# Supplementary Specification to PIP ELSAP04 for AC Uninterruptible Power Supply (UPS) System and Associated Batteries

**NOTE** This version (S-734J) of the specification document provides the justification statements for each technical requirement, but is otherwise identical in content to S-734.

VERSION	DATE	PURPOSE
2.0	March 2024	Second Edition
1.0	November 2020	First Edition

**Figure 1. Single UPS**

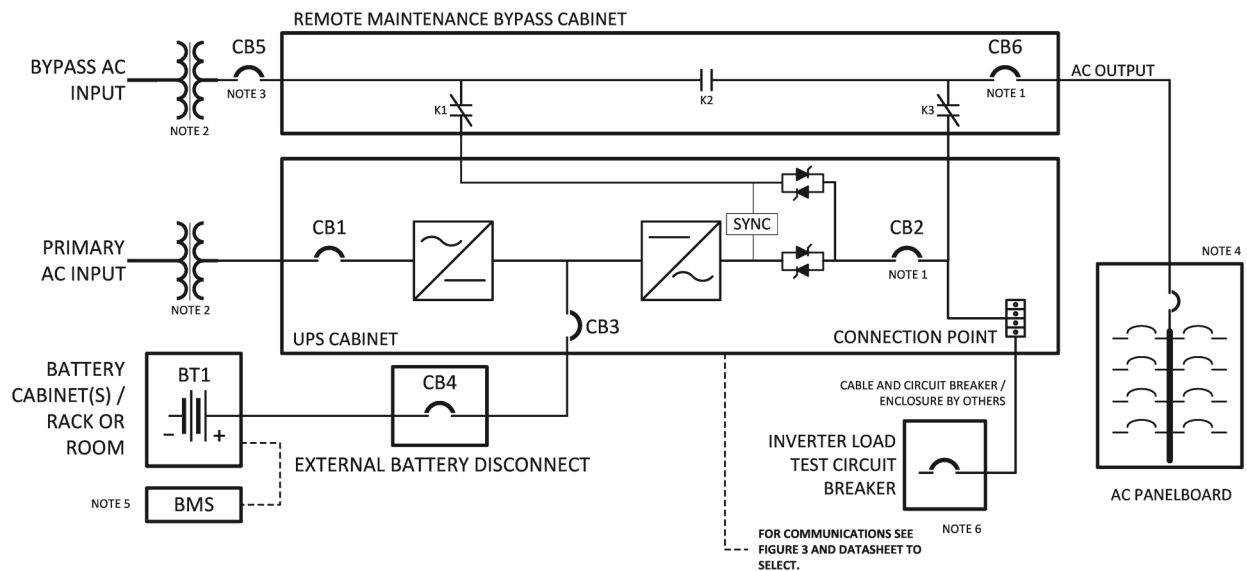
Replace Figure 1 with

NOTE 1 Circuit breaker located in the UPS (CB2) and/or the bypass cabinet (CB6).

NOTE 2 Optional isolation transformer(s) located external or internal to the associated cabinet.

NOTE 3 CB5 located external or internal to the bypass cabinet.

NOTE 4 The AC panelboard, inverter load test CB and external battery disconnect (CB4) are optional items (see the PDS).

NOTE 6 Test CB is supplied and installed by others and is external to the UPS. Terminals to land test cable(s) are provided by the supplier and located in the UPS cabinet.

*This figure has been replaced to more closely align with industrial UPS systems.*
